## **Guardian Building, Sketch Plan Amendment No. 32017008A and Site Plan Amendment No. 82017010A**

**Completed:** 5/14/2021

### **Description**

- Sketch Plan Amendment: Within the approved maximum density, request to increase nonresidential density from 7,496 to 7,827 square feet and correspondingly decrease residential density from 142,414 to 142,083 square feet, and modify public benefit categories;
- Site Plan Amendment: Within the approved maximum density, request to increase nonresidential density from 7,496 to 7,827 square feet and correspondingly decrease residential density from 142,414 to 142,083 square feet, modify public benefit categories, remove all onsite parking, and relocate loading access point;
- Current use: office building;
- Located at the southeast corner of the intersection of Georgia Avenue and Cameron Street;
- 0.68 gross acres zoned CR 5.0: C 4.0, R 4.75, H 145T in the *Silver Spring CBD Sector Plan*;
- Applicant: Guardian Building Associates, LLC;
- Acceptance date: January 27, 2021.

*Figure 3 - Proposed Site Plan Amendment*

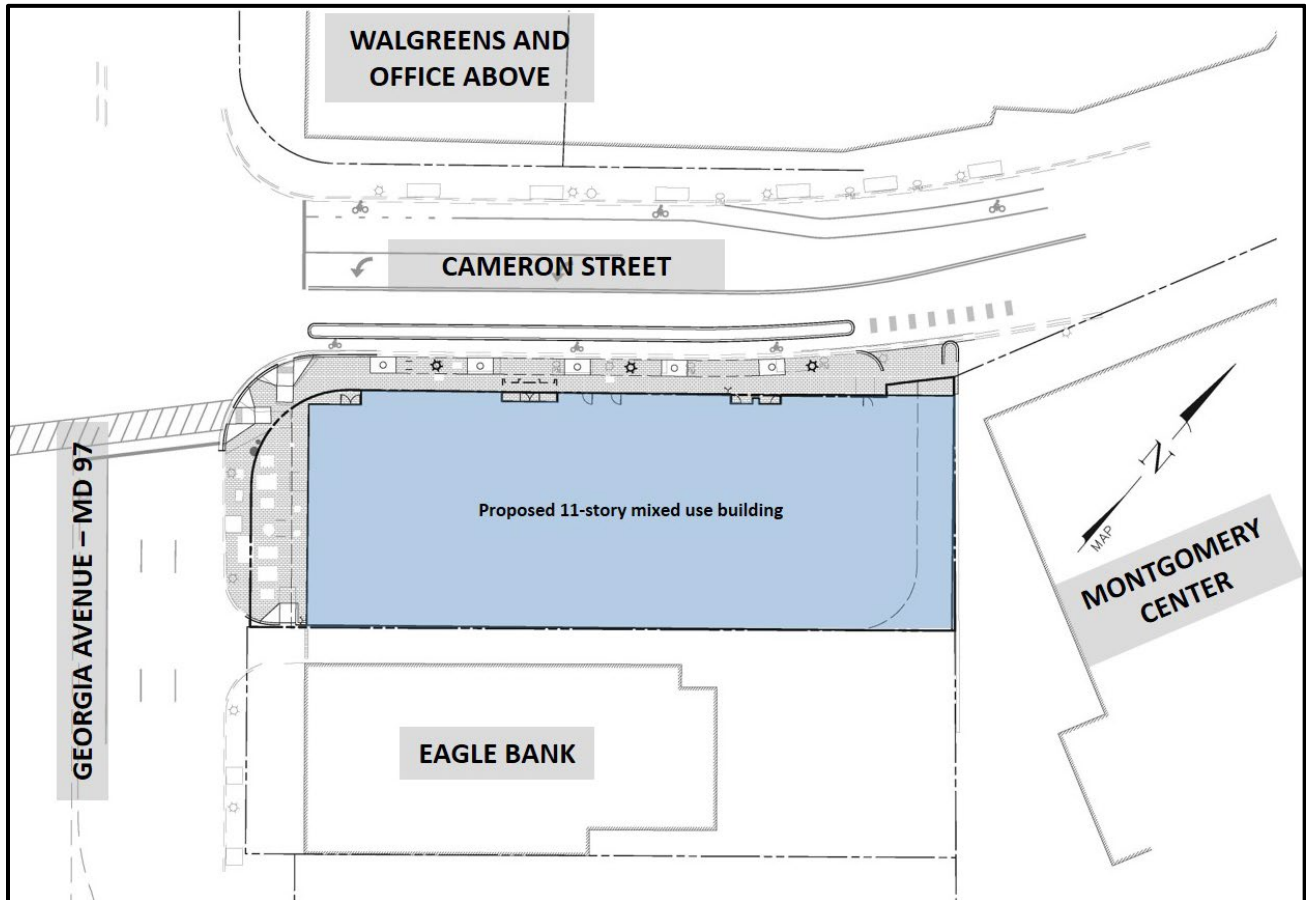
Applicant proposes to remove the previously approved 24 parking spaces entirely from the site, resulting in the removal of 20 public benefit points for structured parking. Lastly, due to the removal of the parking garage entrance, the Applicant proposes to remove the approved loading entrance and instead utilize the existing curb cut for loading and deliveries (which was the previously approved parking garage entrance).

Figure 4 - Proposed Cameron Street Elevation (top) vs Originally approved Cameron Street Elevation (bottom) showing ground floor storefront changes

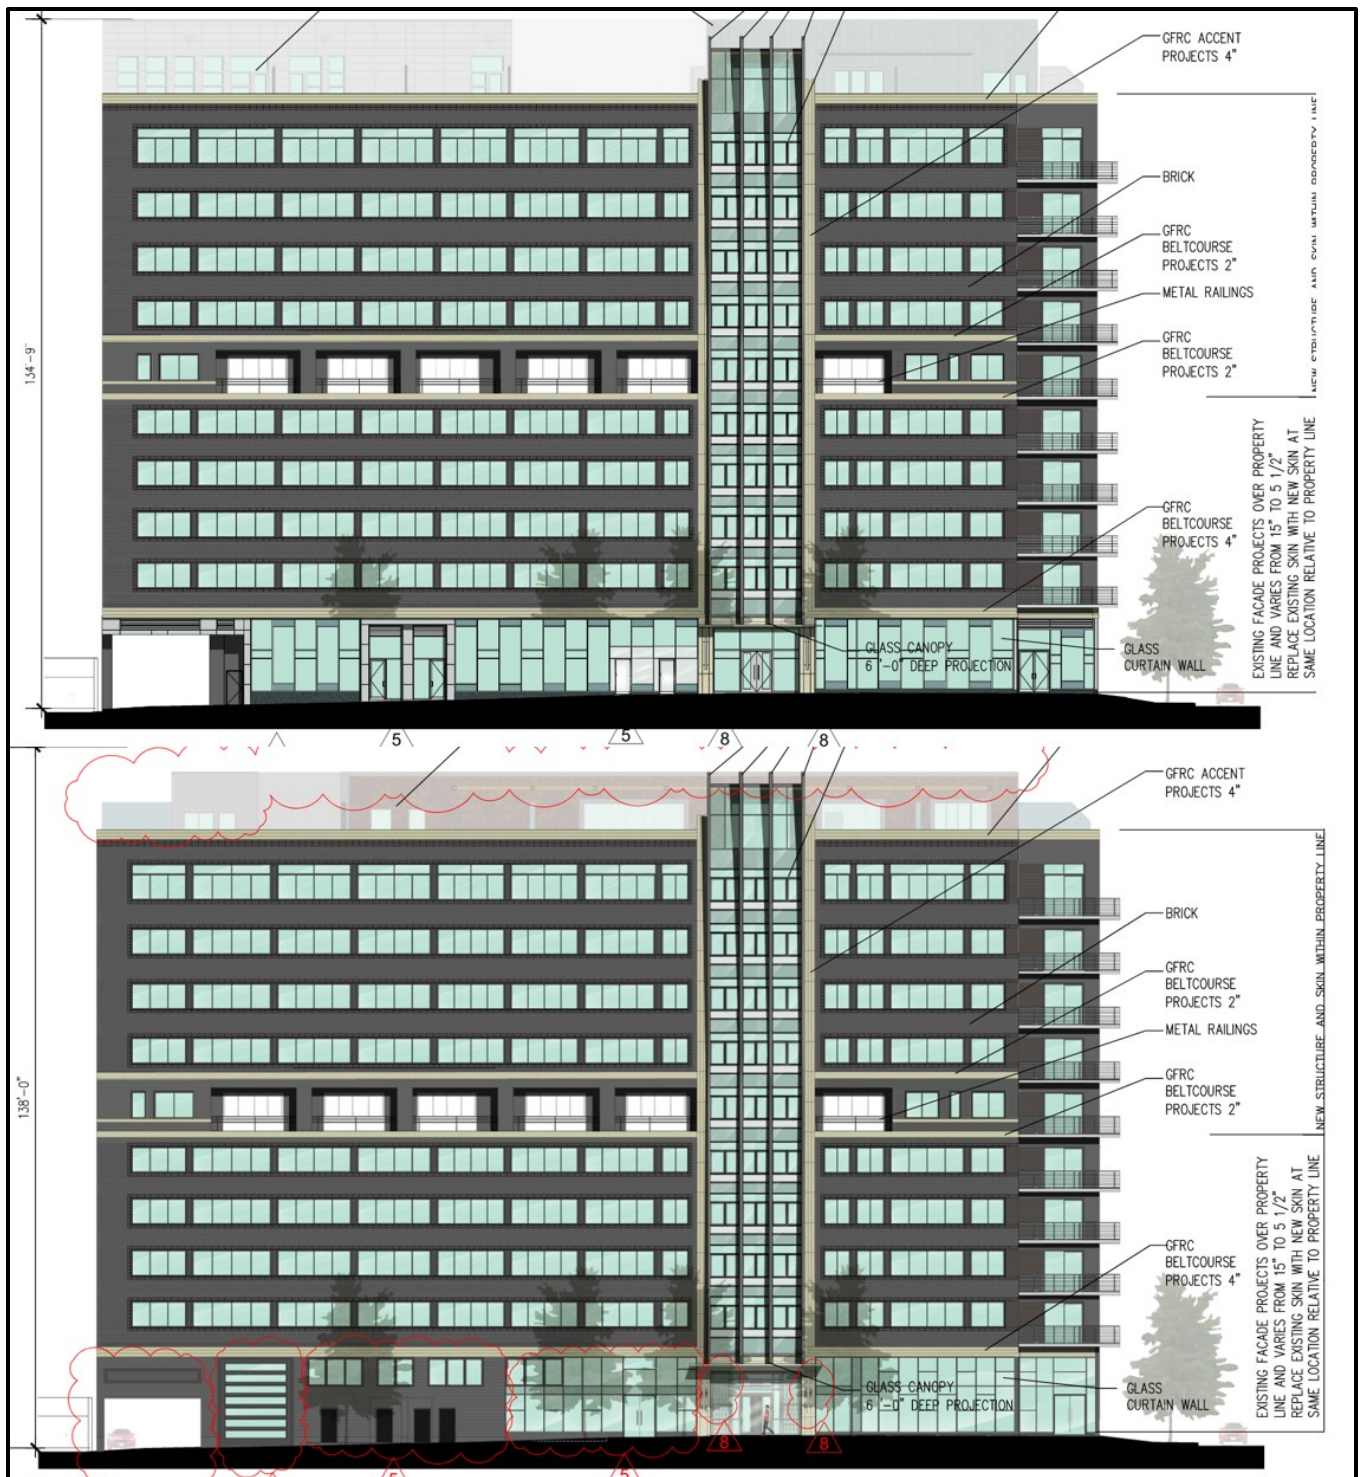
The building design has not changed significantly with these Amendments. The main alterations to the previously approved elevations are most notable along the Cameron Street frontage, where the previously approved driveway entrance for loading and parking garage has been reduced in width from 37 feet to 20 feet, allowing additional storefront space where the loading bay was originally located.

Figure 5 - Access and Circulation

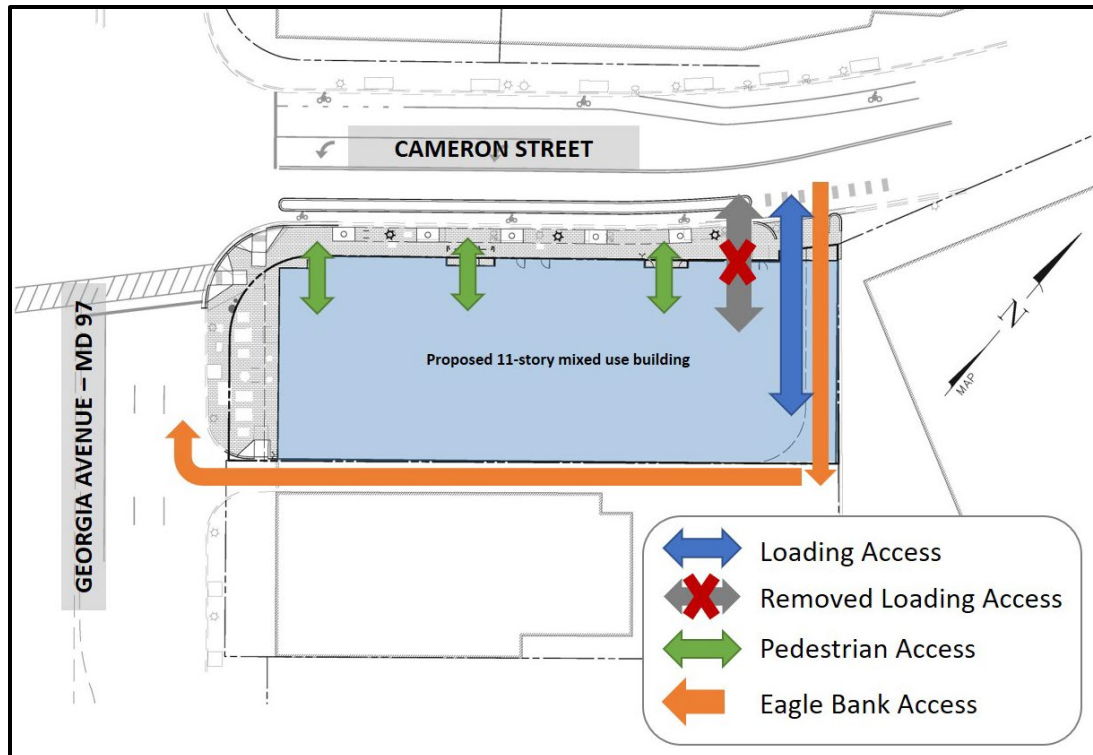
Vehicular access to the Property is proposed directly from Cameron Street. The Amendments propose eliminating the previously approved below-grade parking garage, and therefore vehicular access for the uses on-site will only be necessary for loading, deliveries, and trash collection. Eliminating below-grade parking also eliminates the need for the previously approved separate loading area and corresponding curb cut. Instead, the existing driveway will remain and will provide the only vehicular access point for the project. As shown on the proposed Site Plan Amendment, the driveway apron will be improved to be flush with the sidewalk grade to improve pedestrian visibility and safety.

The existing driveway will continue to provide ingress/egress access to the adjacent ATM drive-thru and surface parking lot located on Parcel 166, immediately south of the Property, currently an Eagle Bank. This shared access easement will be maintained. The driveway is currently 20' wide, which allows for two-way access for the loading and trash collection activities and the existing uses on Parcel 66. This driveway will continue to allow full movement onto Cameron Street. The circulation and traffic operations for the Site are shown in Figure 6.

Figure 6 - Bicycle Parking Exhibit

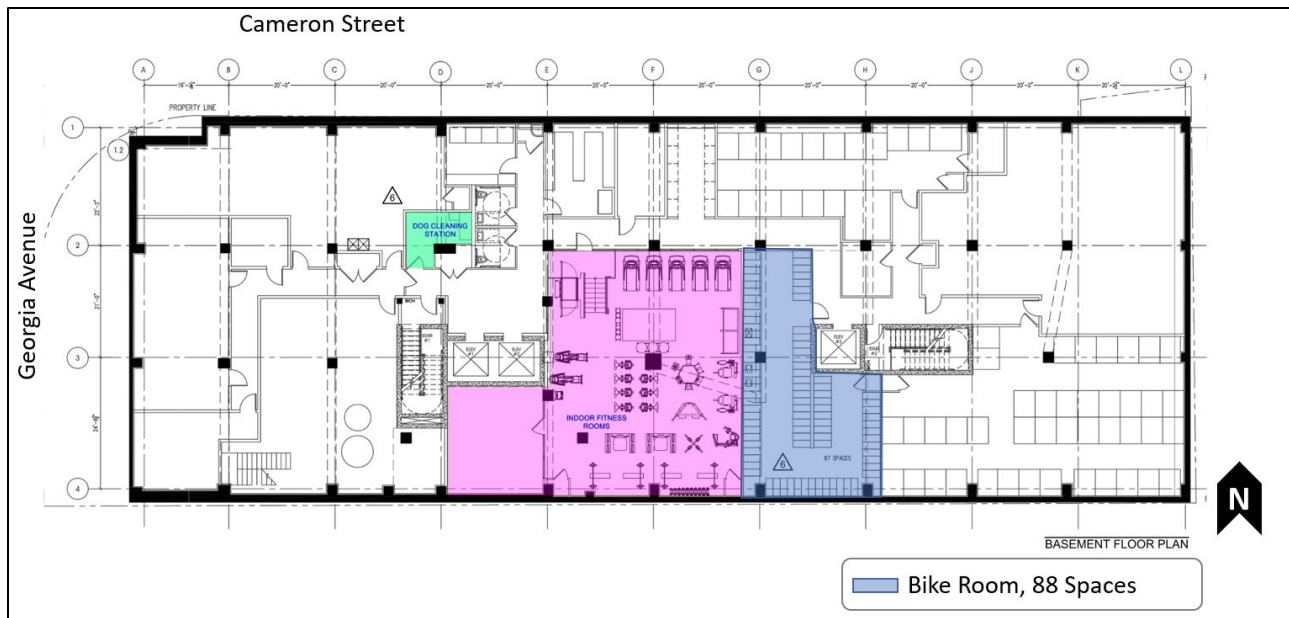
Bicycle parking is provided in a locked room within a secure portion of basement floor of the building. Residents will access the bike room from a secure entrance on Cameron Street. Bicycle parking will be accessed from an elevator located in the lobby of the building. The location and parking structures are shown in the Bicycle Parking Exhibit (Figure 8). Short-term parking is required for both the residential and retail uses and will be located in accordance with the Montgomery County *Bicycle Parking Guidelines*.

- a. The Applicant must provide 87 long-term bicycle parking spaces and 4 short-term bicycle parking space. Short-term public bicycle parking must be installed near the main residential entrance to the multifamily building, to be shown on the Certified Site Plan.
- b. Secure long-term bicycle parking must be installed, internal to the proposed residential building, for resident and retail employee use, and the public spaces must be inverted-U racks (or approved equal) installed in a location convenient to the main entrance (weather protected preferred). The specific location(s) of the public and private bicycle parking must be identified on the Certified Site Plan.
- c. The Applicant must provide a minimum 6-foot-wide clearance within the sidewalks along the Subject Property frontages on Georgia Avenue and Cameron Street, to be shown on the Certified Site Plan.
